PRELIMINARY DRC APPROVAL

Downtown Regional Activity Center

Case Number: R17055

Project Name: Alexan-Tarpon River

Massing Diagram.

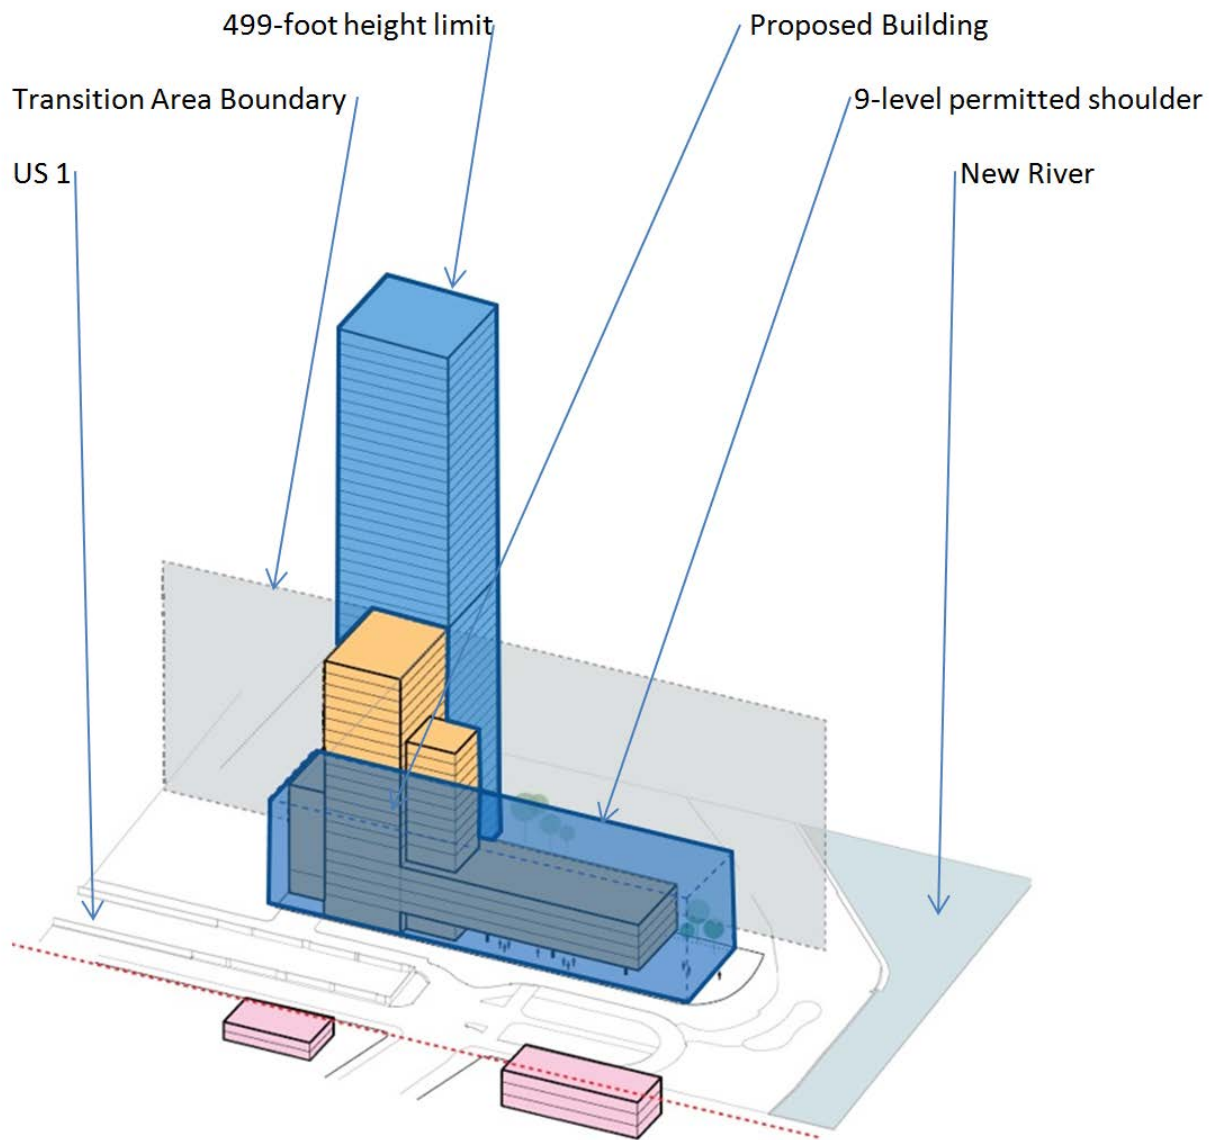
The massing diagram below, created by the applicant, illustrates how the proposed building mass relates to the site and the Type II Transition Area found in the DMP.

The diagram illustrates the following:

- The proposed building (yellow) shoulder height is well below the nine-level maximum (blue);
- A building tower of up to 499 feet in height could be built on the portion of the property beyond the Transition Area;
- The property location, size and NRMP design guidelines would permit a building significantly closer to the river's edge than the one proposed. In addition the proposed building also includes unenclosed ground floor on the north wing which significantly contributes to the public realm.
